117 Preble Street

Schlotterbeck Block Plan Amendment

**RE: Amended Subdivision Plan & Level III Site Plan Application
Schlotterbeck Block – 117 Preble Street**

Subdivision and Site Plan Amendments
117 Preble Street
Level III Amendment to Subdivision and Site Plan
Project ID #2016-078
The Schlotterbeck Building, Applicant

North:  Sheet No.: **L2.0**

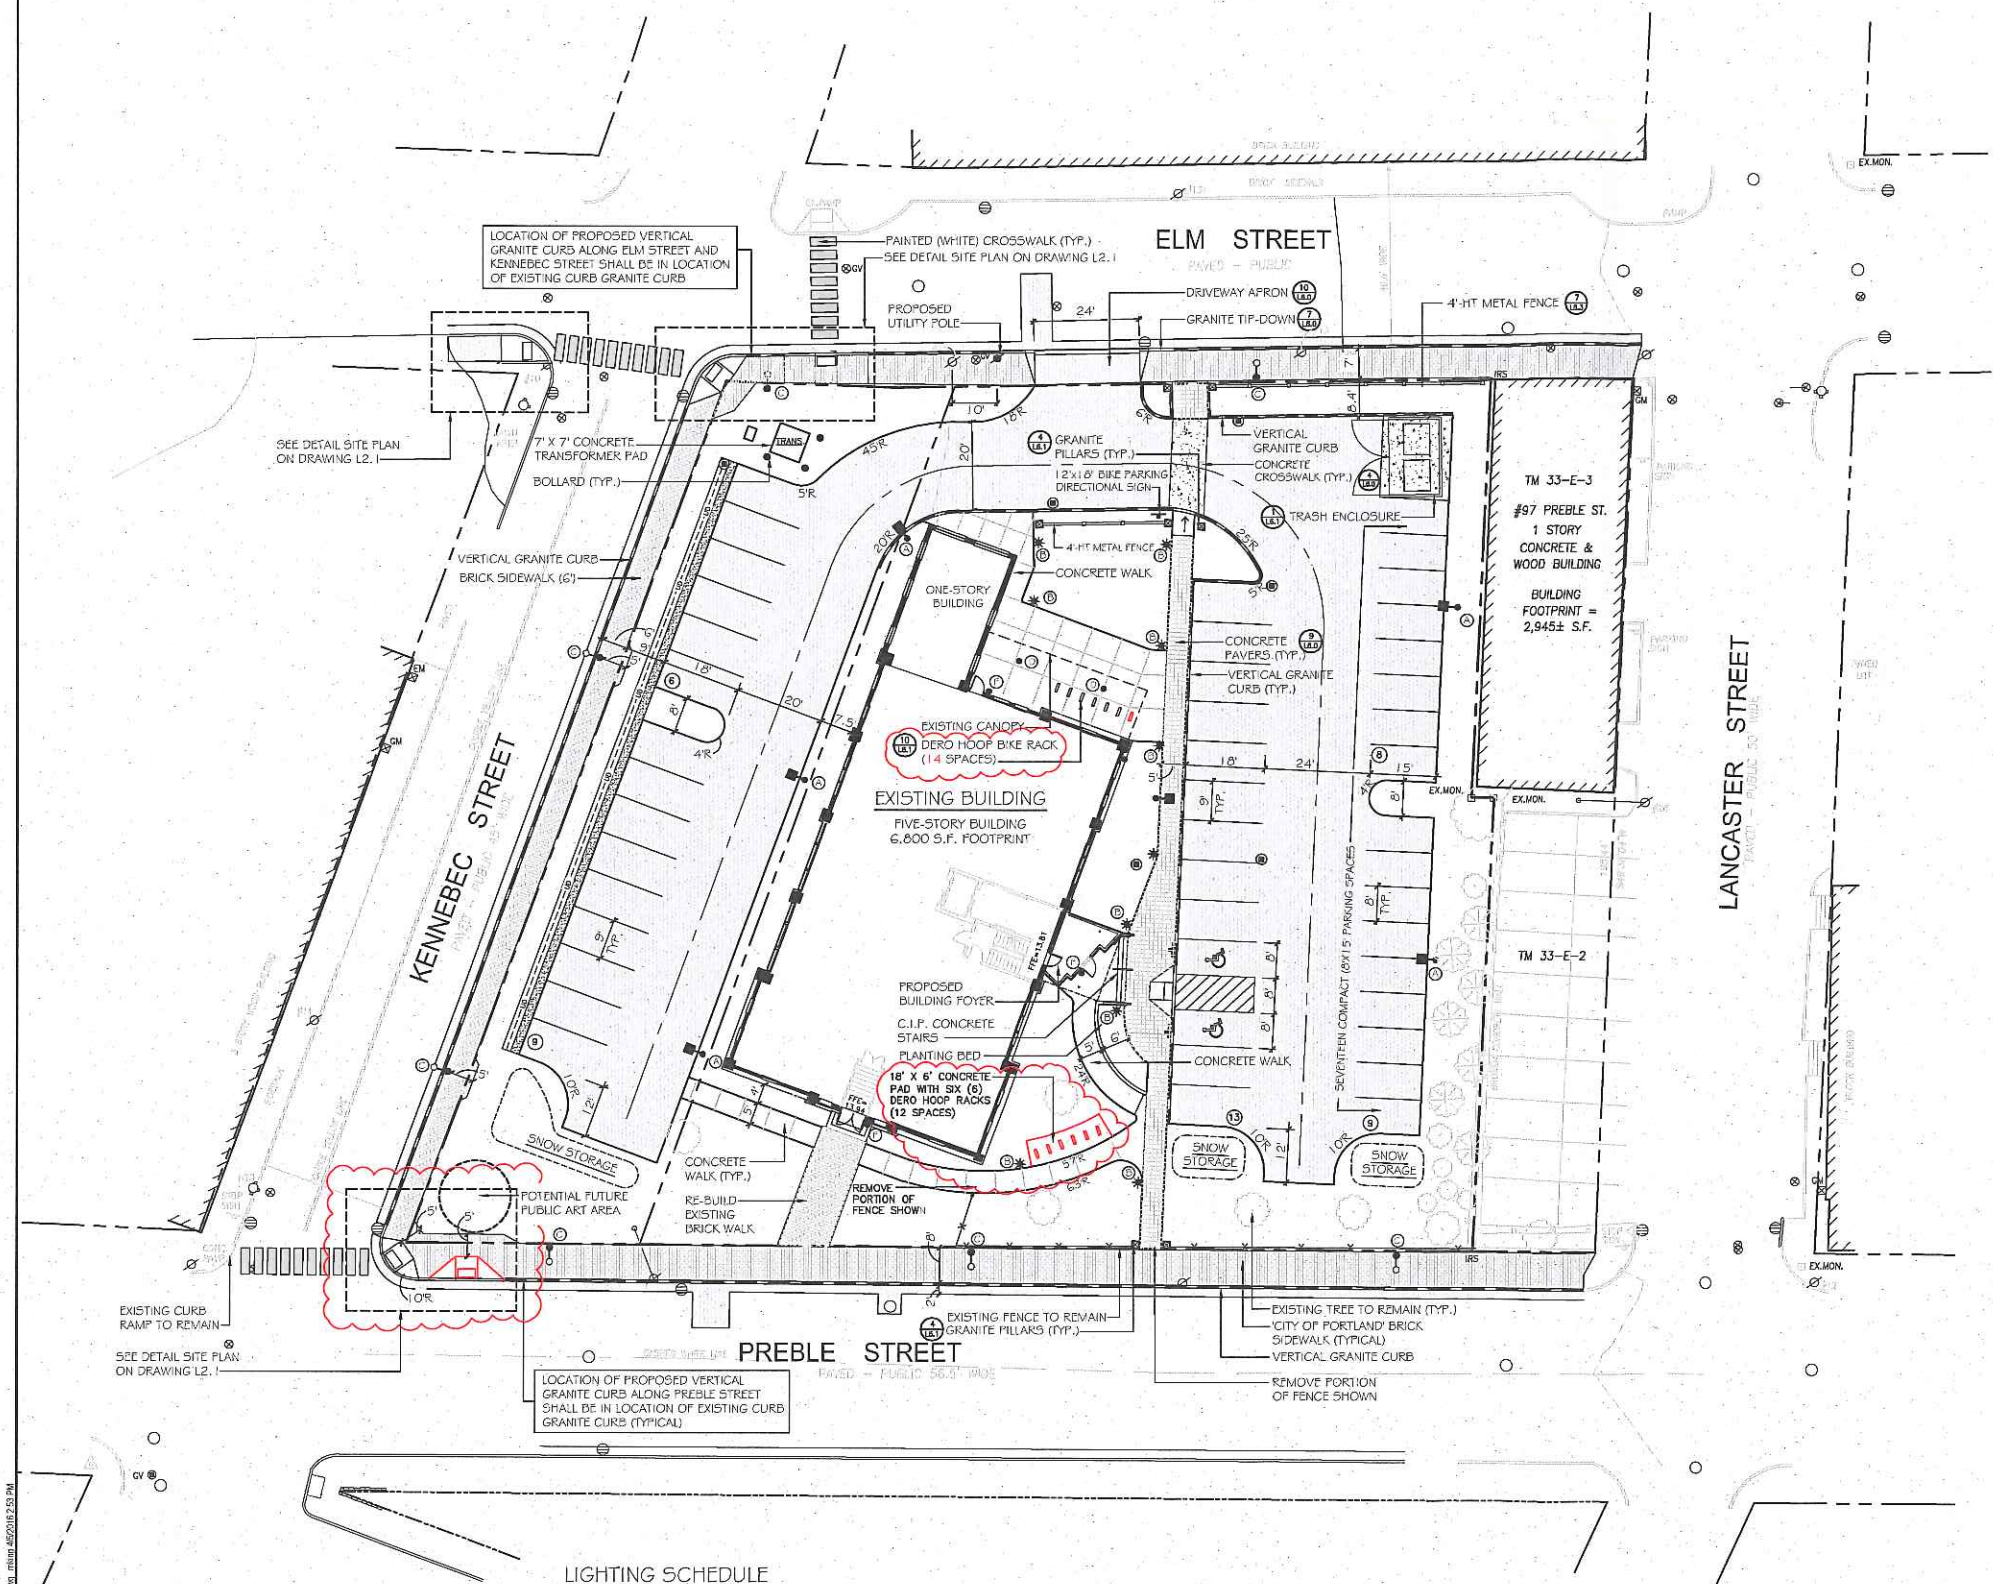
3. Additional Bike Racks: The additional unit eliminates the bike storage room in the basement. As a result, fourteen (14) exterior new bike parking space need to be located on the site. The attached revised L2.0 show an additional bike hitch under the canopy and six (6) additional bike racks on a concrete pad located near the building entrance. With these revisions, thirteen (13) bike loops are provided and 26 bike parking spaces will be provided.

Sheet No.: L3.0

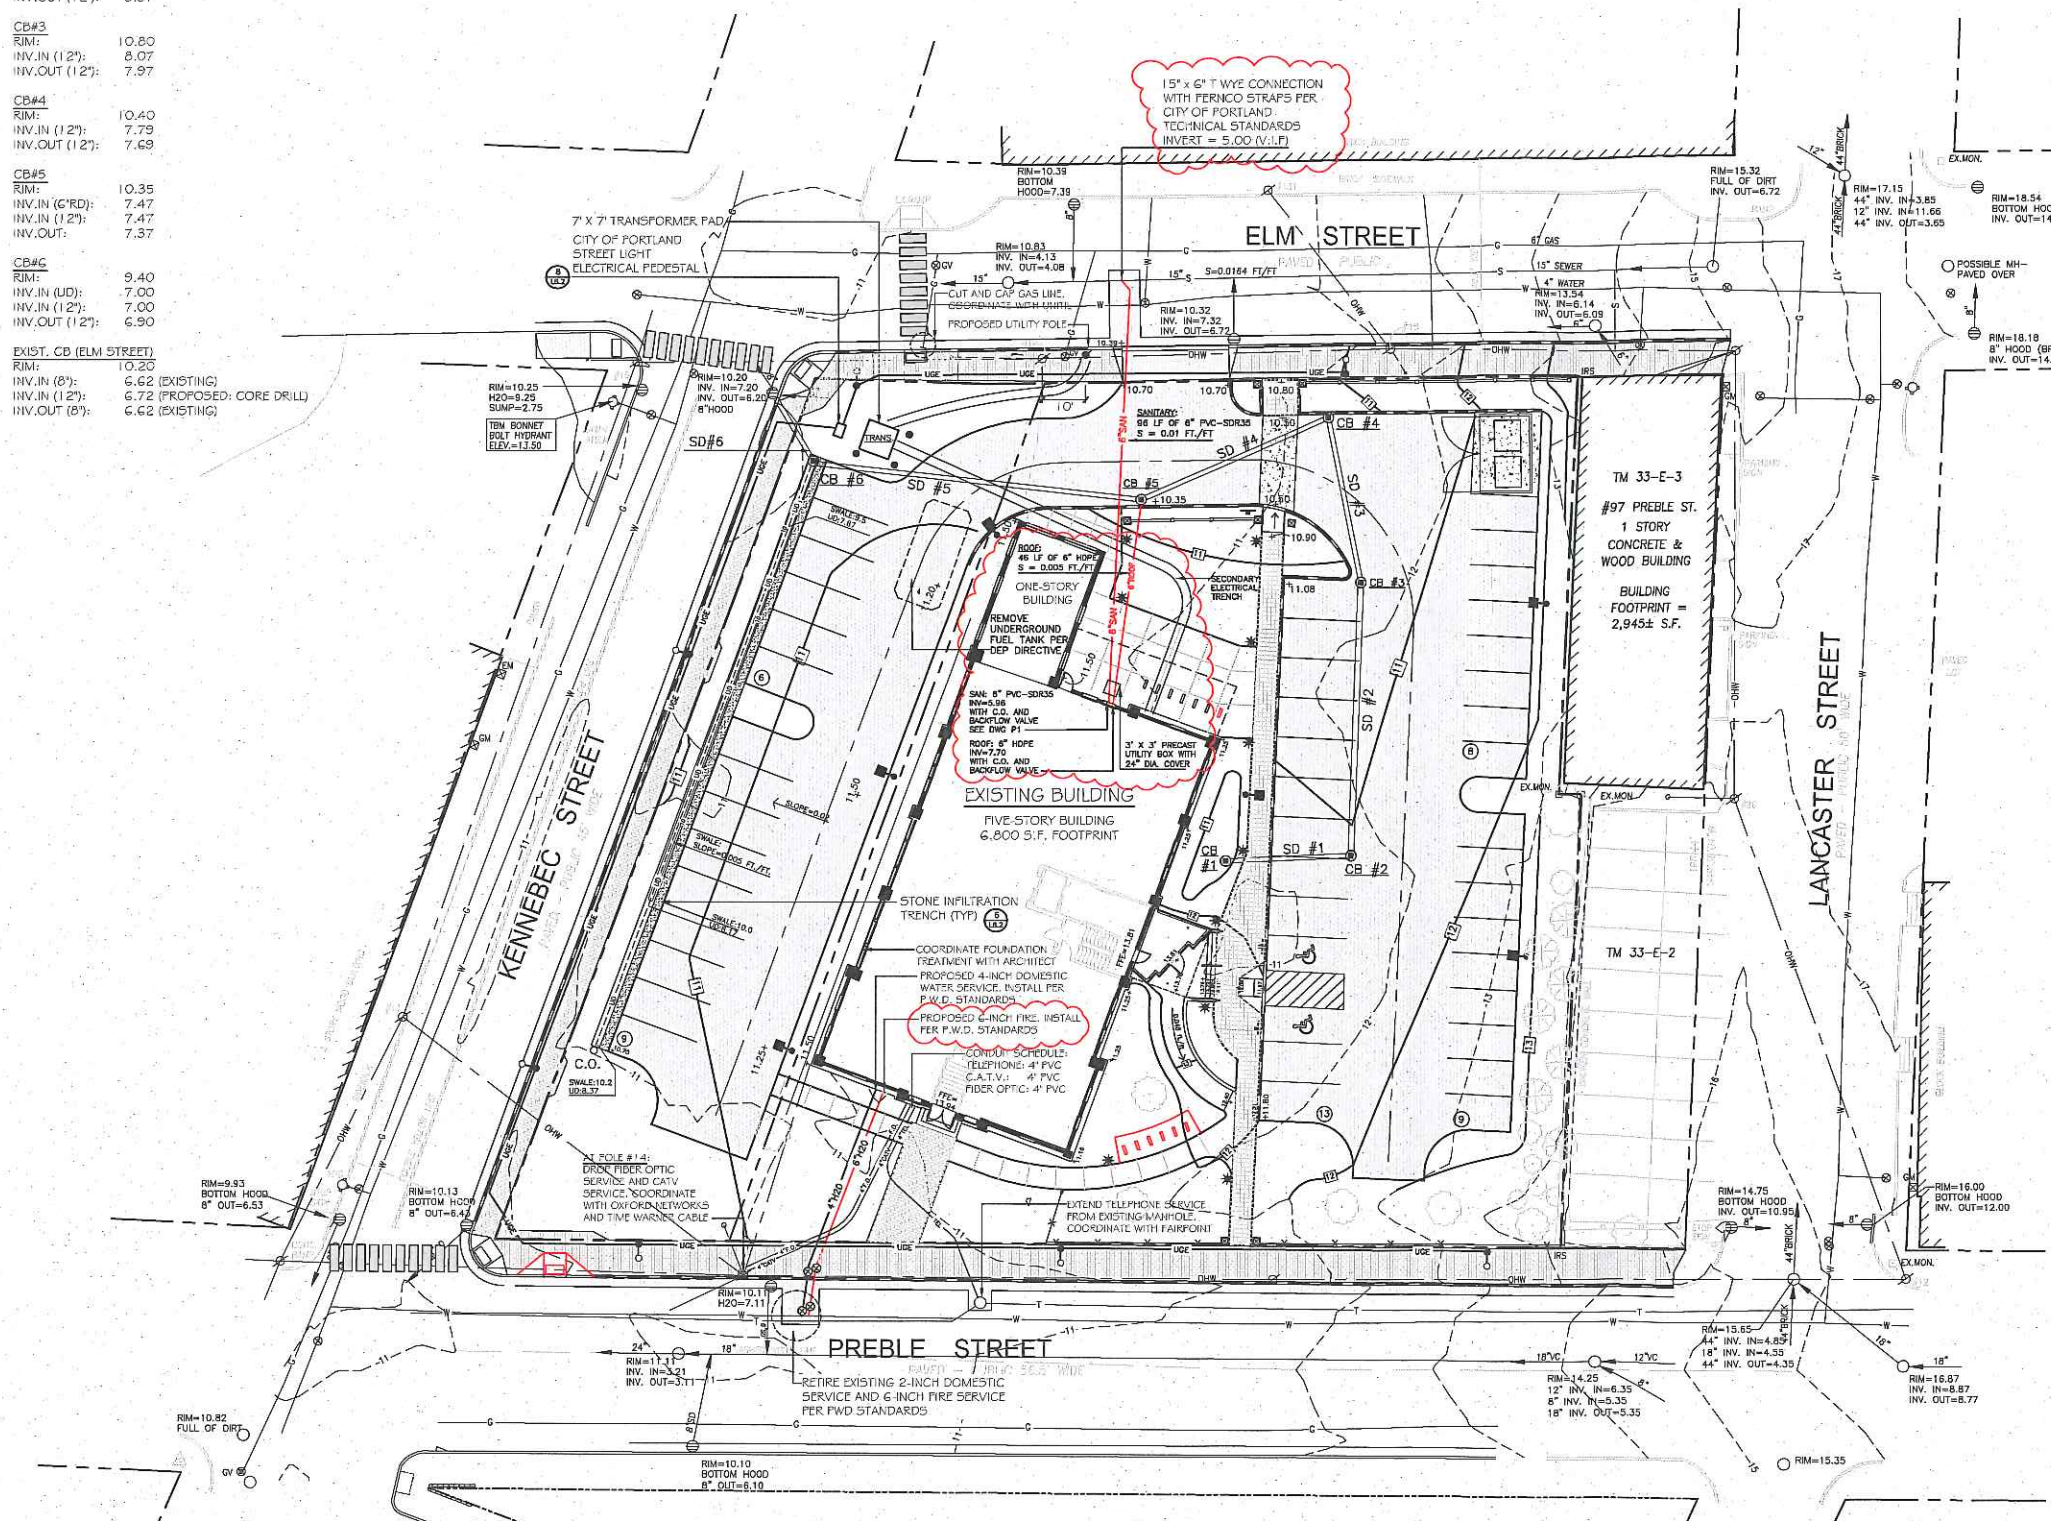
5. 6-inch Fire Water Line: Attached revised L3.0 adds a new six-inch fire suppression water line from Preble Street to the building's fire suppression system. The applicant had planned to continue using the existing 6-inch fire suppression line, but existing 6-inch line is in poor condition.

6. Roof Drain Connection: Attached revised L3.0 shows a new 6" HDPE roof drain connecting to catch basin #5. The existing roof drain pipe is in poor condition and needs to be replaced.

**1st floor plan
lower level plan**

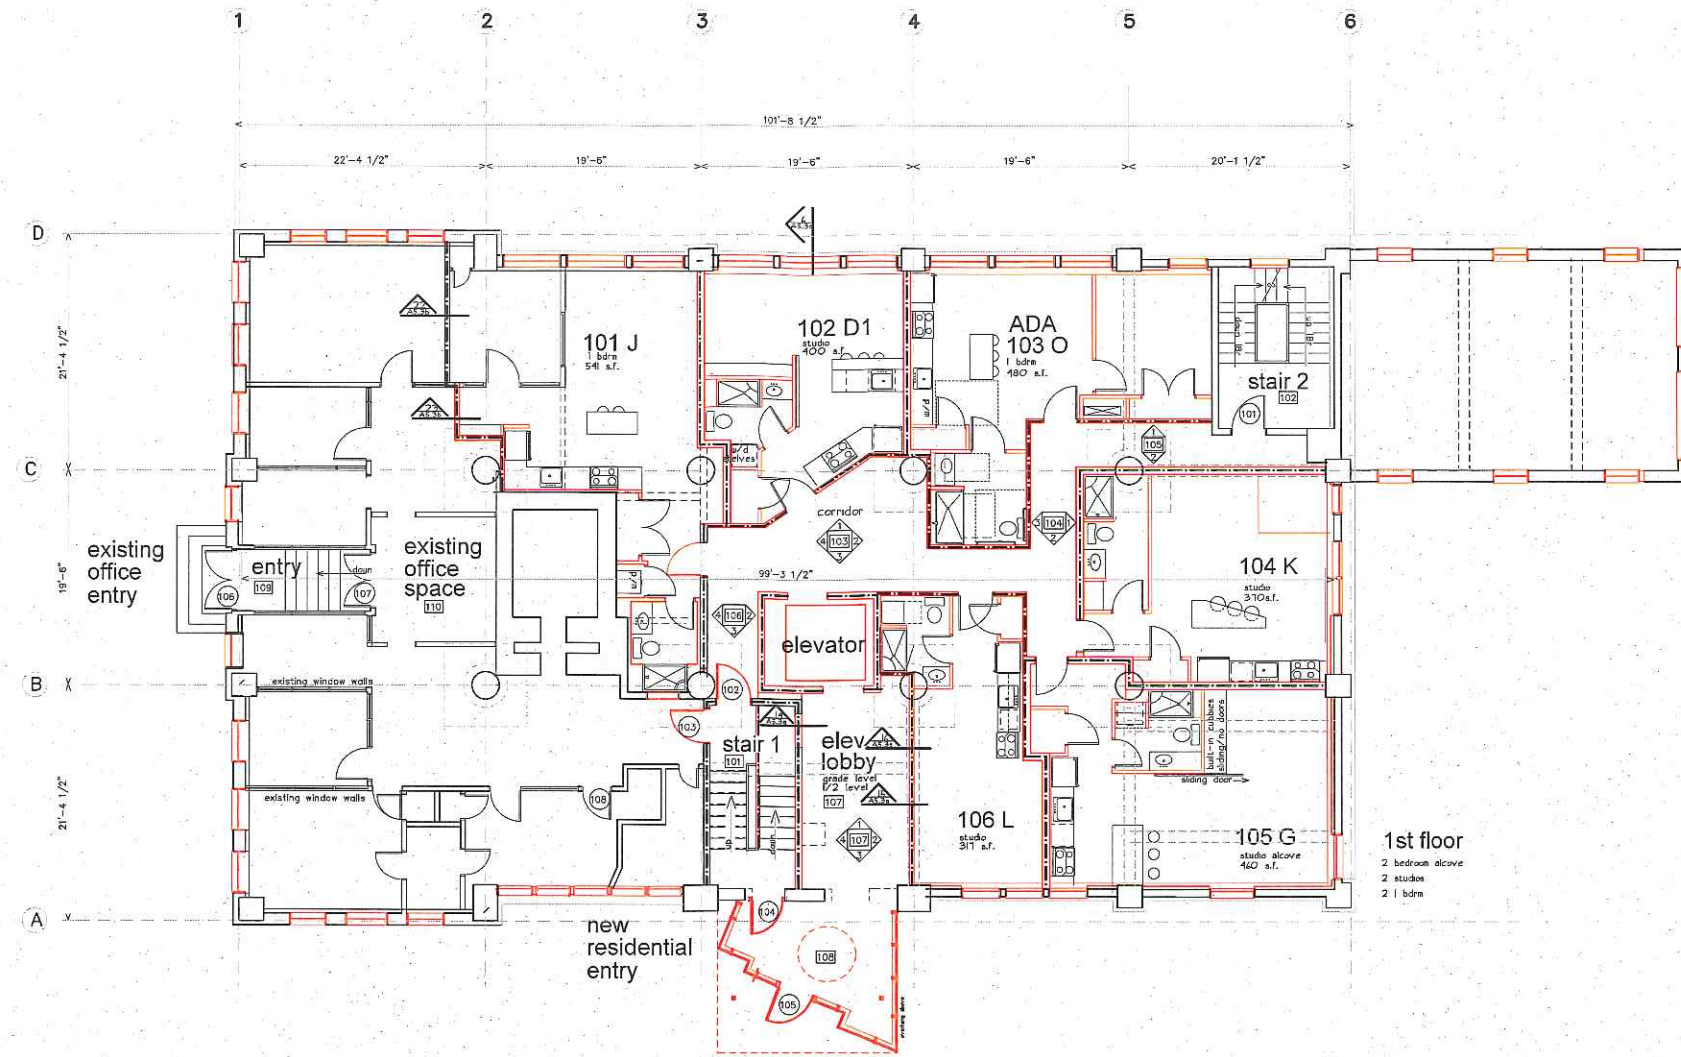
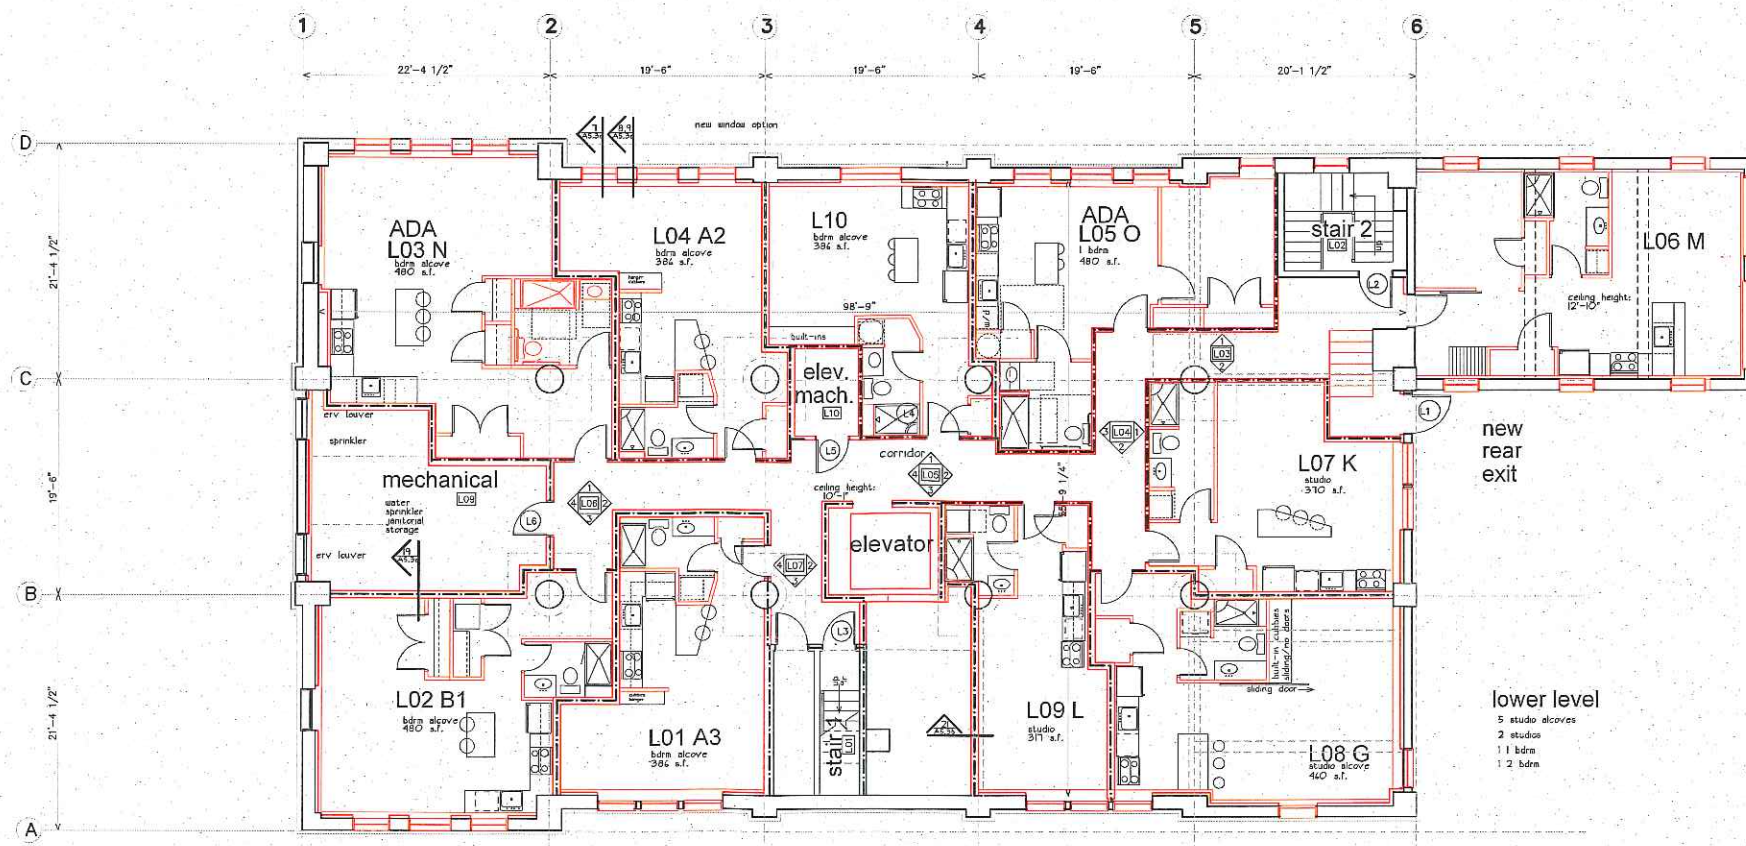
The attached Amended Subdivision Plan and Basement Floor Plan A1.1 have been revised accordingly.
